### **Clinton Keith Village – Response to Comments**

**RESPONSE TO COMMENTS ON THE INITIAL  
STUDY/MITIGATED NEGATIVE DECLARATION FOR**

**CLINTON KEITH VILLAGE RETAIL PROJECT**

(Planning Application 15-0013)

Figure 2. The site plan shows that pedestrians will be forced to pass a driveway in the street.

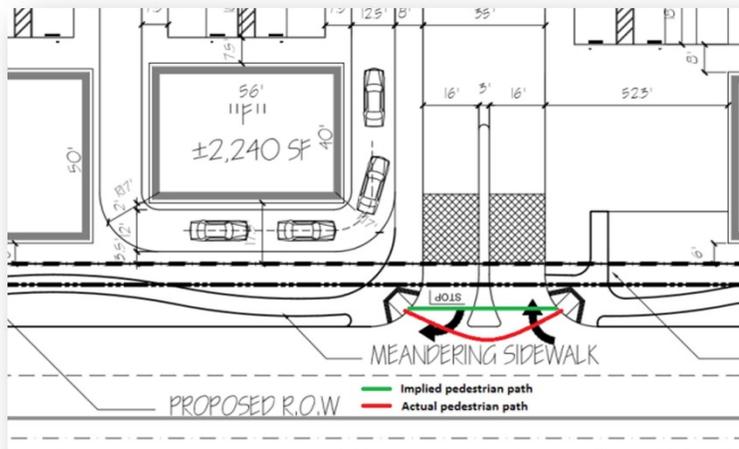
The crosswalks at all the driveways also constitute a glaring error. Using curb ramps that force pedestrians and bicyclists (though legal, the vast majority of the population will not feel comfortable enough to bike in the roadway on any of the planned facilities due to traffic volumes and speeds) to leave the curb in a trajectory that takes them out into traffic is not favorable and we'd really like to see crossings occur as closely to right angles as possible. This issue is really exaggerated at Driveway A,

which if built as proposed in the Site Plan, would unbelievably encourage sidewalk users continuing past that entrance to pass around the channelization island in the roadway itself. That is an extremely obvious safety

hazard that will be created at that location, made even more

egregious by the fact that it would be on the direct path of any children traveling to school at Ronald Reagan Elementary from the housing located south of Clinton Keith. It is crucial that this manufactured conflict be avoided, which is another benefit realized by using a median on George Ave. itself instead of in Driveway A. Additionally, we recommend that the crosswalks across all of the driveways be built as raised tables and marked in the high visibility "continental" style. The same convention also needs to be carried into the site itself, with all crosswalks of pedestrian/ADA pathways within the site being also constructed as raised table crossings a minimum of four inches in height. Finally, we would also like to see the crosswalk stretching across the parking lot between Buildings "B" and "E" be at a bare minimum of 8 feet wide, but 10' would be preferred. This will also control speeds in the parking lot and keep people from speeding through the aisles.

The City Engineer will work with the project applicant and the applicant's engineer to determine whether changes in the driveway design are appropriate. If reconfiguration is necessary, appropriate changes will be made and incorporated into the final design of the proposed project.

Appendix A. Roadway cross-sections

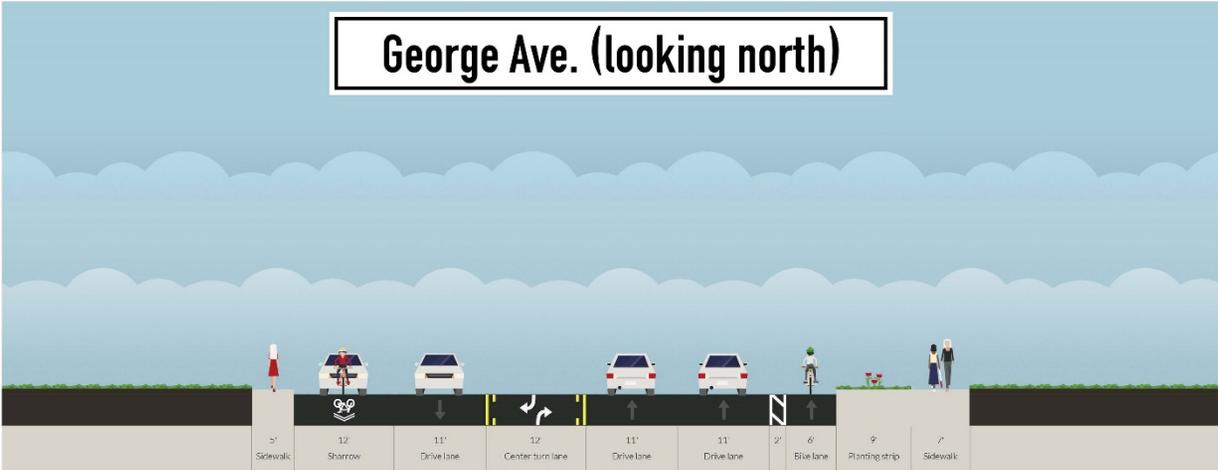
Though no bike facilities are currently located directly on George Ave. or Clinton Keith road, any improvements being built need to ensure that they are included. The *City of Wildomar Community/Regional Roadside, Offroad Multi-Use Trails* map shows that an east-west link is planned on La Estrella St. and a north-south on Salida Del Sol, both of which are located approximately half a mile from the project site and would be good options to help people access the site by means of active modes. The half-width improvements recommended for George Ave. and Clinton Keith need to provide a clear connection to those future linkages for bicyclists. To accommodate, there need to be several modifications to the road sections that are proposed to be used. Due to the hills in the immediate area of the project, the preferred configuration is a climbing bike lane/descending 'sharrow' couplet on both Clinton Keith and George Ave. The sharrows should also be combined with R4-11 signage indicating that full lane usage by bicyclists is to be encouraged and expected. Optionally but ideally, R5-1b and R9-3c signage should also be installed at intervals, especially on the northbound side of George Ave. where people are likely to take a shortcut to the store and children are more apt to head home from school. Additionally, research has shown that lanes of the widths proposed are actually less safe than narrower options (Karim, 2015). That needs to be addressed, and the process of doing so provides additional space for providing bicycle facilities. The rightmost/right turn only lane on westbound Clinton Keith Rd. directly adjacent the project site is far too wide at 18 feet. A buffered bike lane should be added to the proposal that is transitioned to a through bike lane to the left of the right turn only lane when within 200 feet of the intersection with George Ave. The proposed widths should be reduced to 11-feet for standard and 12-feet for the outside lanes. Doing so provides ample space available to install a buffered bike lane on the uphill side of both streets. Recommended road sections for both George Ave. and Clinton Keith Rd. are included in Appendix A.

Cross-section to be used for the construction of George Avenue (modified Riverside County Secondary).

The City Engineer will work with the project applicant on the final engineering of the off-site street improvements to address bicycle usage.
